**CITY OF WINTER PARK
PLANNING AND ZONING BOARD**

**Staff Report
August 4, 2015**

REQUEST OF THE WINTER PARK MEMORIAL HOSPITAL FOR:
CONDITIONAL USE APPROVAL TO RENOVATE AND EXPAND THE EMERGENCY SERVICES COMPONENT OF THE HOSPITAL AND TO BUILD A NEW FIVE-STORY PATIENT WING ON THE EAST SIDE OF THE HOSPITAL LOCATED AT 200 N. LAKEMONT AVENUE, ZONED O-1, PURSUANT TO THE APPROVED MASTER PLAN.

EXHIBIT 'A'
EXISTING & PROPOSED CONDITIONS

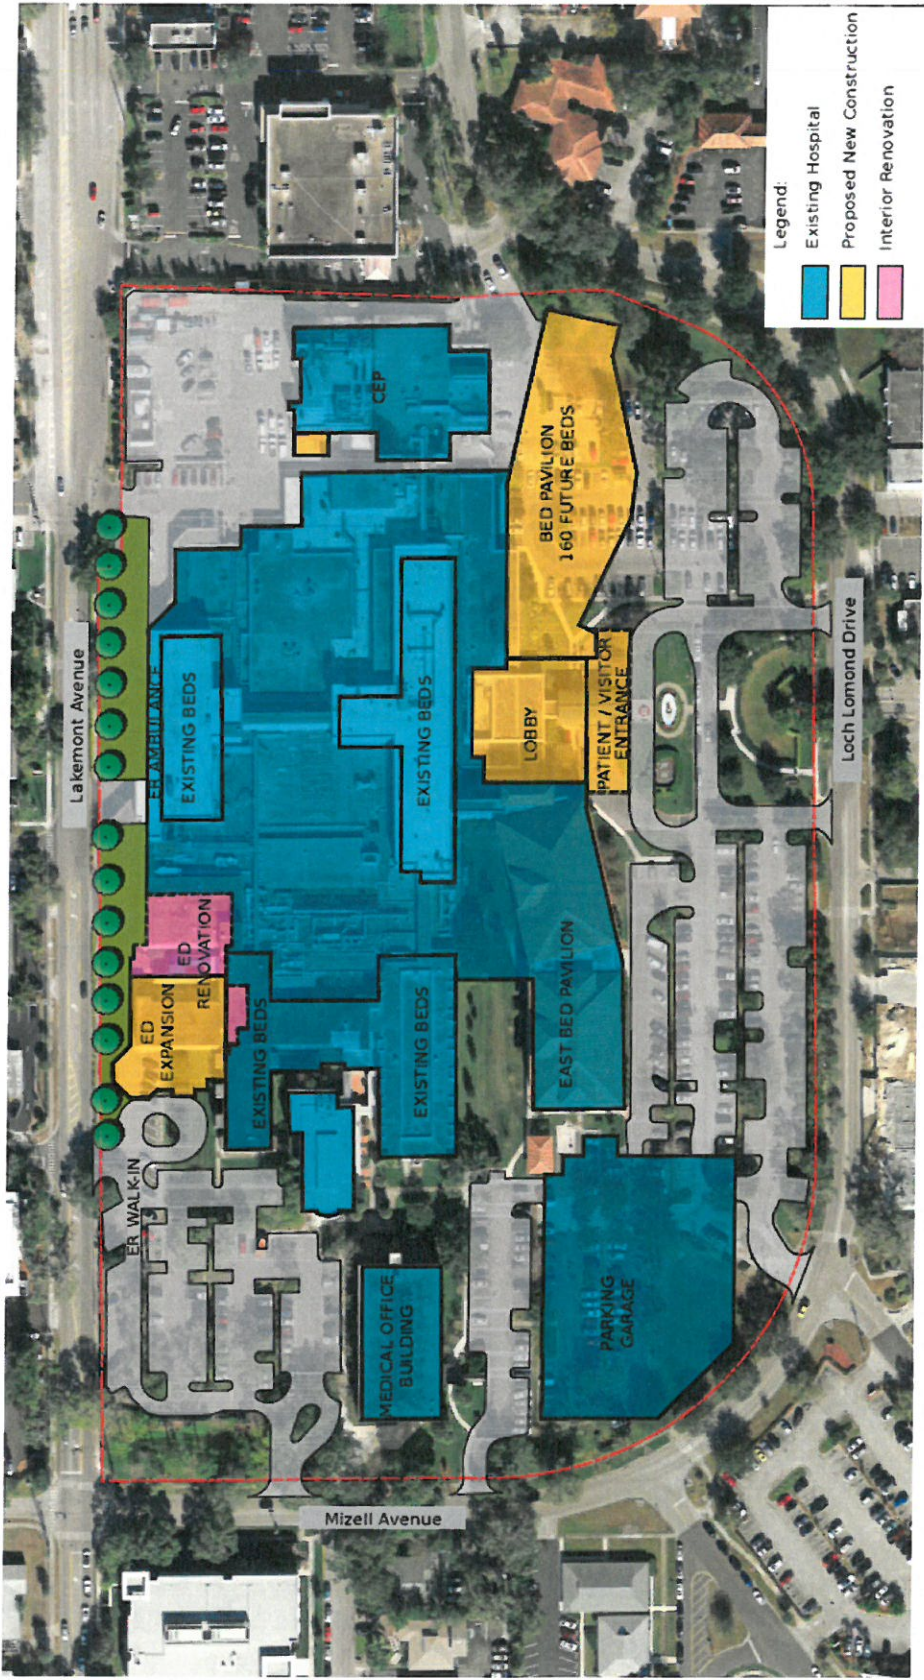
Staff has reviewed the adopted Master Plan and has determined that even with the height relocation from Lakemont to the east side of the campus for five stories on the new proposed wing, that the applications meet the intent of the Master Plan. The applications meet the parking requirements, the height, the square footage and the bed count within the Master Plan.

Staff Recommendation is for APPROVAL of the Preliminary Conditional Use with the following conditions:

1. The Hospital continue the exterior architectural enhancements to the Lakemont Avenue façade of the Hospital (on the two floors above the Emergency Services façade) in order to provide architectural consistency on the same building wall with the new façade.

2. The Hospital will provide by January 1, 2016, a Master Stormwater/Drainage (campus wide) Plan including a schedule of infrastructure improvements and implementation dates.

3. The Hospital shall provide a visual and sound attenuation buffer along Lakemont Avenue to screen and buffer the proposed expansion to the physical plan facilities necessary to serve these two projects. This buffer shall be part of the final development plan submittal.

Rollins Practice Fields, Conceptual Placement Study
 Winter Park, Florida
 JUNE 25, 2015

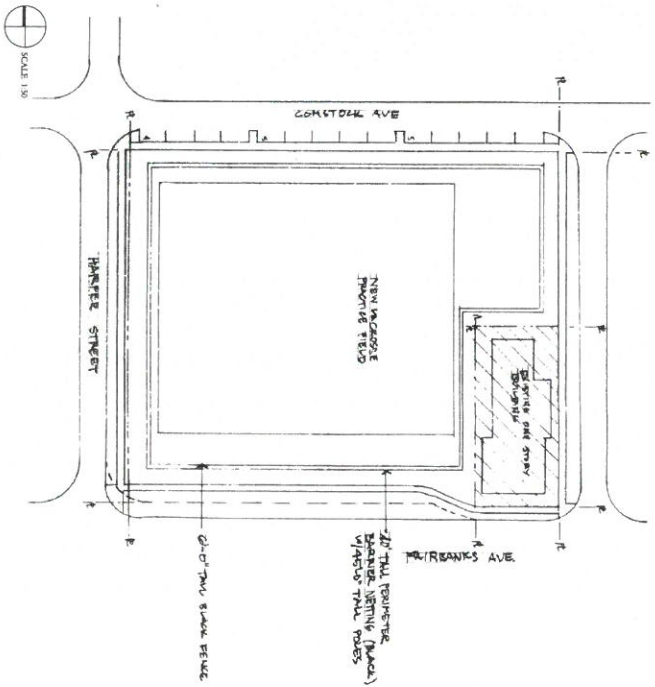
The concerns of the planning staff involve the elements of the plans that include the field night lighting and safety netting. The proposed field light poles are shown at 70 feet tall. The commercial (C-3) zoning has a 55 foot tall height limit and thus the design will be to conform that 55 feet. Even with that height reduction, the image of those four 55 foot tall light poles is a concern. Added to those structures are the 50 additional poles, that are 45 feet tall spaced around the entire field to support 40 foot tall netting. The netting is necessary to contain the lacrosse balls, soccer balls, etc. from going out onto the streets causing accidents. While the netting can be made less visible when viewed straight on, it will always be visible when viewed at an angle. The concern is how 55 foot tall light poles and 50 other poles that are 45 feet tall with netting surrounding the site are going to be complementary to the streetscape image of Fairbanks Avenue. What no one wants is for the site to look like the backside of a driving range on all four sides.

In recognition of this situation, Rollins College has agreed to utilize a more transparent netting material (than depicted in the attached drawing). Rollins also recognizes that the visual "success" of the netting along Holt Avenue for Sandspur Field is largely because of the oak trees that screen the view along Holt. Thus, there is a need to increase the setback for the field along the Fairbanks and Harper frontages in order to provide sufficient space for oak tree canopy to grow. The changes are not dramatic. Reducing the field dimensions by 10 feet east/west and 7 feet north/south provides enough space for an oak tree canopy screen to be installed and mature. Staff is requesting a landscape plan condition for implementation.

- 1. That the field dimensions, perimeter fencing and netting be relocated 10 feet further from Harper Street and 7 feet further from Fairbanks Avenue in order to provide sufficient space for the planting and canopy of new oak trees to be added to screen the support poles and 40 foot tall safety netting.**
- 2. That an operation plan be undertaken with the City to establish the timing of night use and time for field lighting to turn off and that the plan establish the timing and method for dropping the netting.**
- 3. That a landscape plan be approved by the City incorporating a hedge screen for the perimeter fencing; oak tree screen for the Fairbanks Avenue and Harper Street sides and palm tree plantings on the interior street sides.**
